Re: Kilarc-Cow Creek {FERC

P-606} CEQA

SOUTH COW CREEK DIVERSION DAM AREA

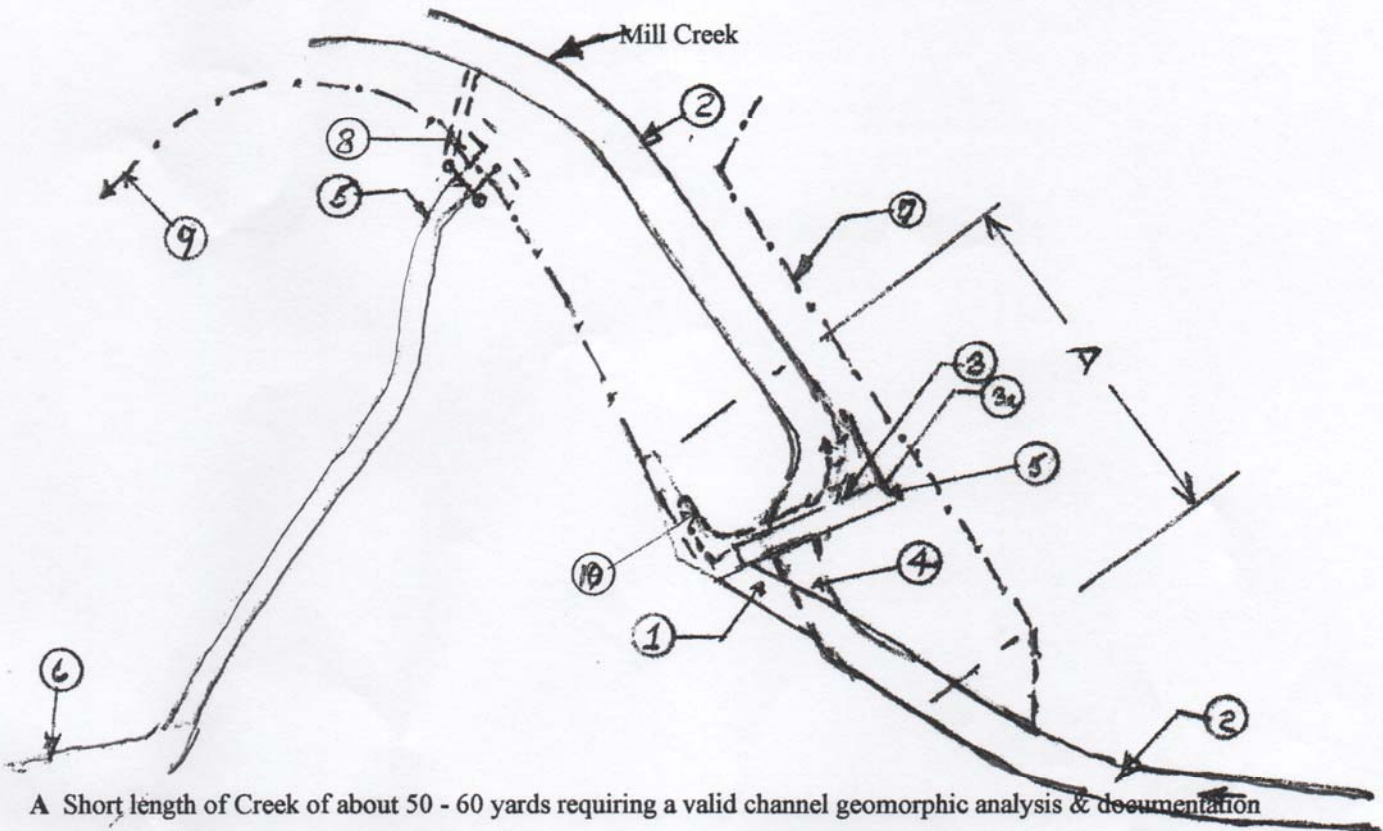
a. Area 1 is a channel reshaped by man in 1907 to create an entrance to the main canal. It is now the existing last leg of thalweg before the diversion works. How is the stream channel going to magically put itself on a natural course, and not try to do a 90 degree kink at the canal head works unless some sort of bank restoration efforts in this region are undertaken? Such efforts could be as

b. The precise location objective of a post dam channel (Area 4) is not yet estimated. However, it will not be as approximately shown in Attachment I unless all those involved grasp the very basic and simple fact that the third step of the cut-off walls is below “grade level”. Some means {preferably natural material} needs to be anchored against and along at least one of the walls in this area to bring

it up to least the level of the middle section of the cut-off walls. If this is not done, it is obvious the post dam channel course will bias itself towards and against the abutment on the main canal side. Similarly the span of the dam between abutments is on the order of four times the typical channel width within Wagoner Canyon. Hard right and left stops {Preferably natural material} can be anchored against the cut-off walls in the appropriate location to the define the post dam channel width

c. Where the retaining wall now intersects the dam face & right abutment {Area 3a} is far removed from the pre-dam channel bank. It should properly be described as protecting a vertical bank created

by man and erosion - not simply the stream channel bank. How is this area to be addressed on dam

removal? Hopefully not just per that outlined in the LSA. This retaining wall can appropriately treated in combination with rip rap, sediment barriers and other bioengineering stabilization techniques at the cut-off walls to readily recreate some resemblance of the pre-dam canyon bank in

A Short length of Creek of about 50 - 60 yards requiring a valid channel geomorphic analysis & documentation

- ① Man created thalweg into Main Canal 1907 time area
- ② Now existing (& likely pre-dam) natural Channel of South Cow Creek above & below dam
- ③ Rough estimate of pre-dam natural bank slope {possible 20-30 feet removed from retaining wall
- ③a Retaining wall intersection with dam abutment and face of dam
- ④ Rough estimate as pre-dam thalweg above & below dam
- ⑤ FERC Access Road "A"
- ⑥ Approximate location along Road A of past staging areas @ top of canyon for work at Fish Screen area & main canal
- ⑦ Mill Creek Canal
- ⑧ Main Canal Spillway #1
- ⑨ Main Canal
- ⑩ Thalweg about 60% of year { fish screen area back down fish ladder and then parallel to dam face 7, then turn
